15557-TUL-XX-XX-RP-C-91002 Issue 01

Land East of Longwater Road, Finchampstead, Longwater Road, Wokingham, RG40 3TS.

Discharge of Condition Consultation (Application Number 260289)

Planning Response for Conditions 7, 9 & 11.

Plot 3 Private Car Vehicular Swept Path

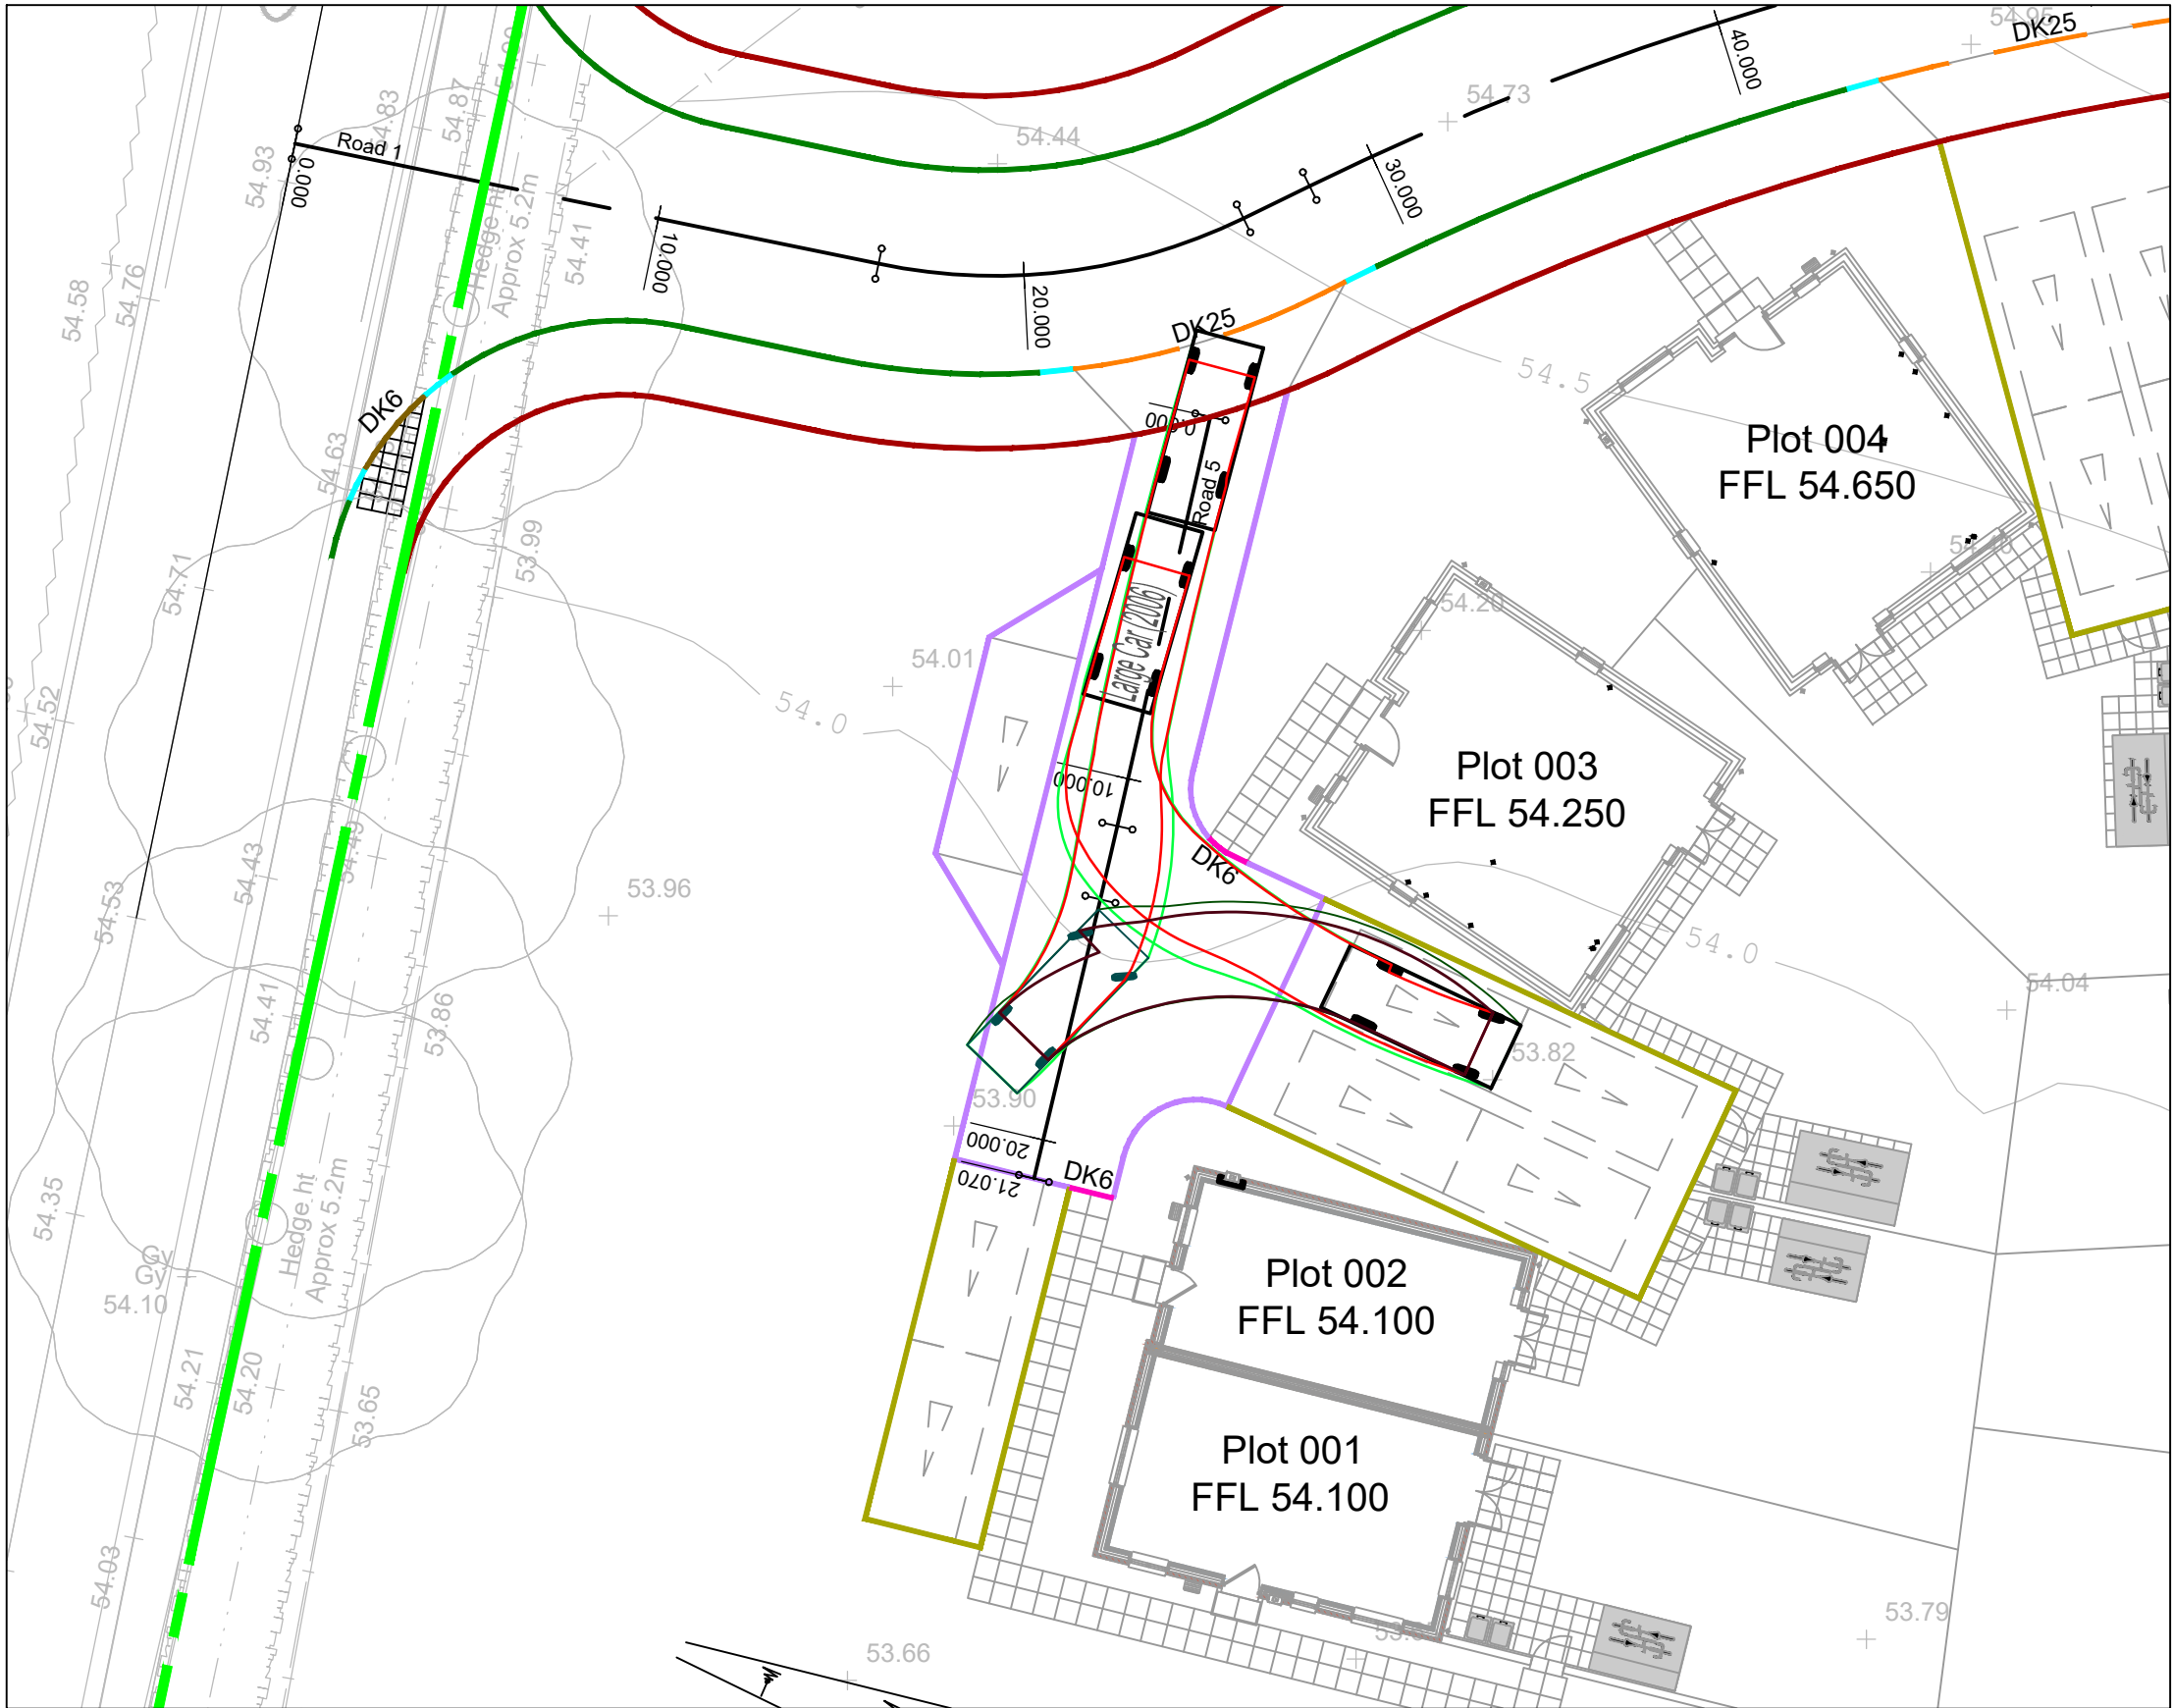
"Highways is concerned that the parking spaces for plots 1, 2 and 3 require the neighbouring parking spaces to be used for manoeuvring. This will need looking at. Highways is content for details of parking to be secured through a planning condition."

The applicant is required to provide a revised arrangement or demonstrate there is sufficient space through swept path analysis of a large saloon car

- *Width of the parking bays proposed on site should be clarified/confirmed.*
- *Swept path analysis is required for the internal roads which show a refuse vehicle and delivery van can pass a large modern car. Swept paths for a large modern car should also be completed for the car parking spaces proposed on site.*

Swept paths undertaken for a Large Car with the following results;

Plot 1 - vehicle can manoeuvre out of parking space in reverse and turn without entering the parking bays of plots 2 and 3.

Plot 2 - vehicle can manoeuvre out of parking space in reverse and turn without entering the parking bays of plots 1 and 3.

Plot 3 - vehicle can manoeuvre out of parking space in reverse and turn without entering the parking bays of plots 1 and 2.

Swept paths shown on drawing GUI003-TUL-XX-00-DR-C-95-325_P01

- Swept paths provided for refuse vehicle and delivery van passing and car for parking spaces.
